# Access Compliance Report

## Public Rights-of-Way

Intersection ID: 19925	Main Street: FAIRVIEW_RD	Cross Street: PROVIDENCE_RD	Location: W
ADA ID: 9EB5693978BE	Ramp Type: PerpDiag	Initial Pass/Fail: Fail	Overall Compliance: No
Severity Score: 12.5			
Codes/Mitigation Info/Possible Solution		Field Measurements/Component Compliance

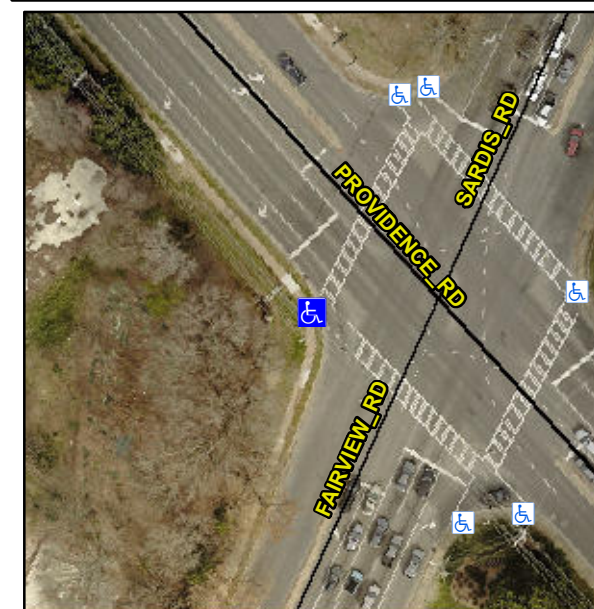
**Remove & Replace Curb Ramp With Two New Directional Ramps or Equivalent.**

**Not Found, R304.2.2**

Compliance	Description	Data	Compliance	Description	Data
N/A	Ramp Length (in)	49.0	No	Ramp Slope (%)	10.0
Yes	Ramp Width (in)	48.0	Yes	Ramp XSlope (%)	0.5
N/A	Flare Type LT	N/A	N/A	Flare Type RT	N/A
N/A	Flare Slope LT (%)	N/A	N/A	Flare Slope RT (%)	N/A
N/A	Flare Traversable LT?	N/A	N/A	Flare Traversable RT?	N/A
N/A	Landing Length (in)	N/A	N/A	DWS Provided?	N/A
N/A	Landing Width (in)	N/A	N/A	DWS Contrast?	N/A
N/A	Landing Slope (%)	N/A	N/A	DWS Length (in)	N/A
N/A	Landing X Slope (%)	N/A	N/A	DWS Full Width?	N/A
N/A	Landing Curb? (Y/N)	N/A	N/A	DWS Offset (in)	N/A
N/A	Shared Landing?	N/A			
N/A	Gutter Ponding?	N/A	N/A	Gutter Slope (%)	N/A
N/A	Gutter Lip Ht (in)	N/A	N/A	Gutter X Slope (%)	N/A
N/A	Painted X Walk1?	Yes	N/A	Painted X Walk2?	Yes
	X Walk 1 Direction	To SE		X Walk 2 Direction	To NE
N/A	X Walk 1 Width (in)	106.0	N/A	X Walk 2 Width (in)	86.0
	X Walk 1 Slope (%)	2.3		X Walk 2 Slope (%)	0.3
	X Walk 1 X Slope (%)	0.3		X Walk 2 X Slope (%)	1.8
